Amendments to the Drawings:

Serial No.: 10/666,342
Art Unit: 2682

Attorney's Docket No.: H0004415-1246
Page 13

FIG.
Figure 15

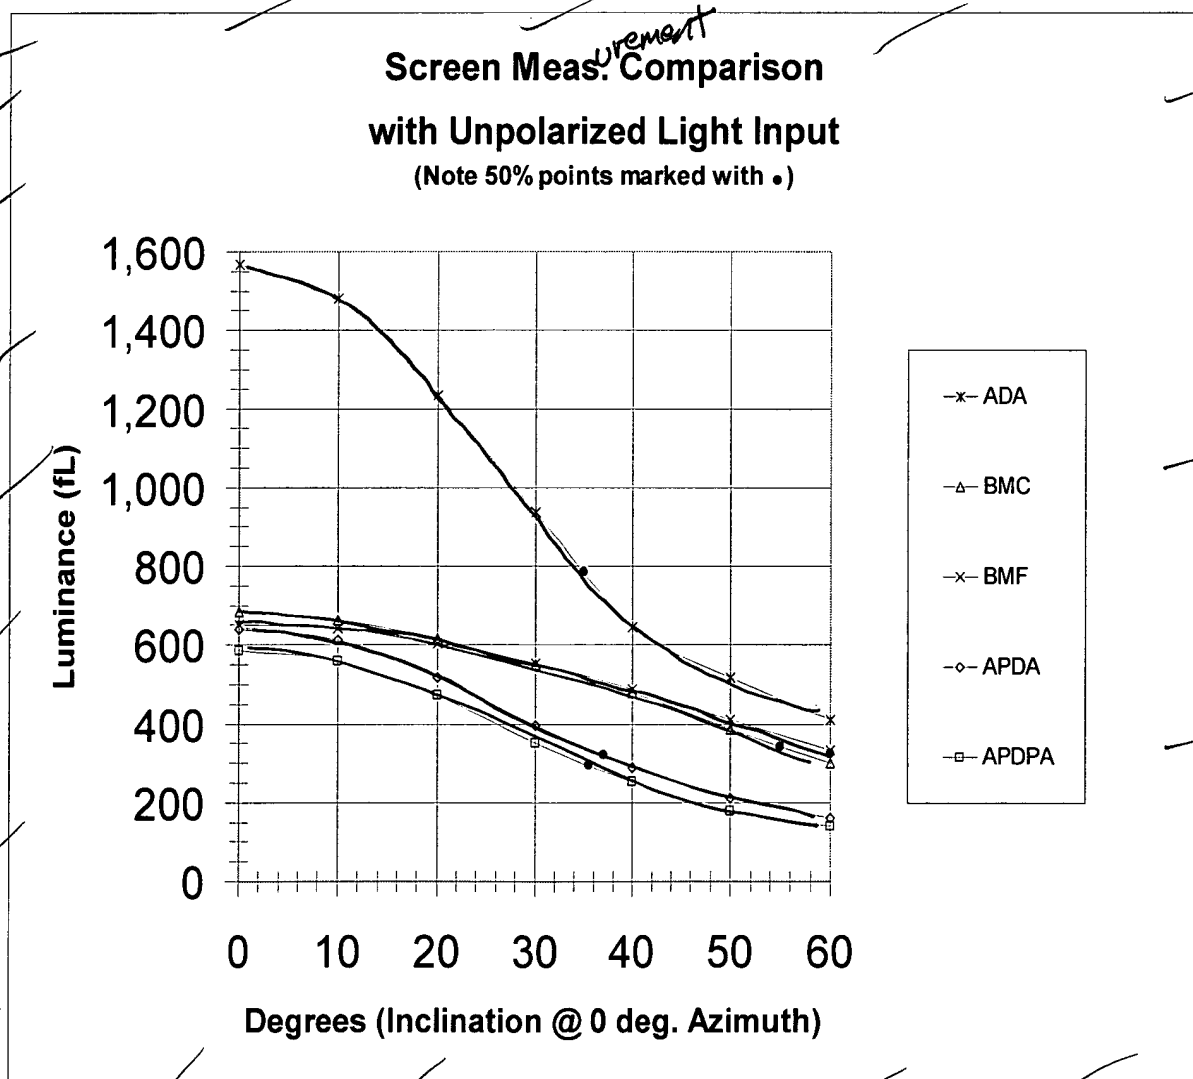
As required by the Office Action, replacement sheets for Figures 15-17 and 20 (as well as new Fig. 21) are being submitted herewith for entry. Also submitted are Annotated Marked-up Drawings that show how Figures 15-17 and 20 have been modified. It is noted that the main modification in the graphs of Figures 15, 16 and 20 is that the lines have been darkened.

FIG
Figure 16

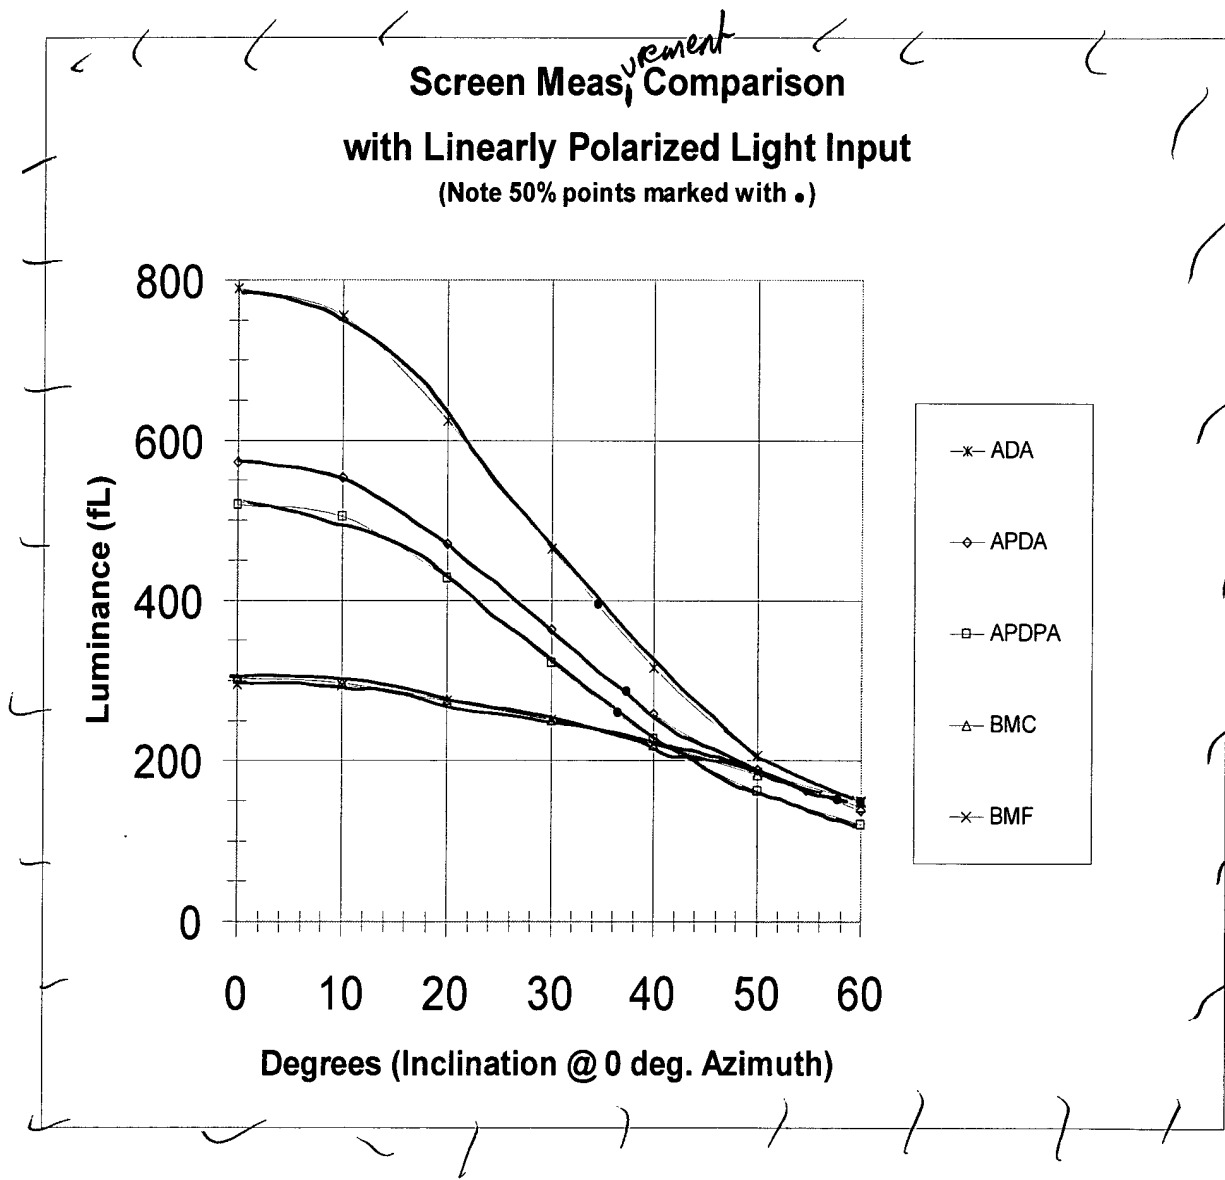
~~Screen Measurement Comparisons
with Polarized Light Input~~
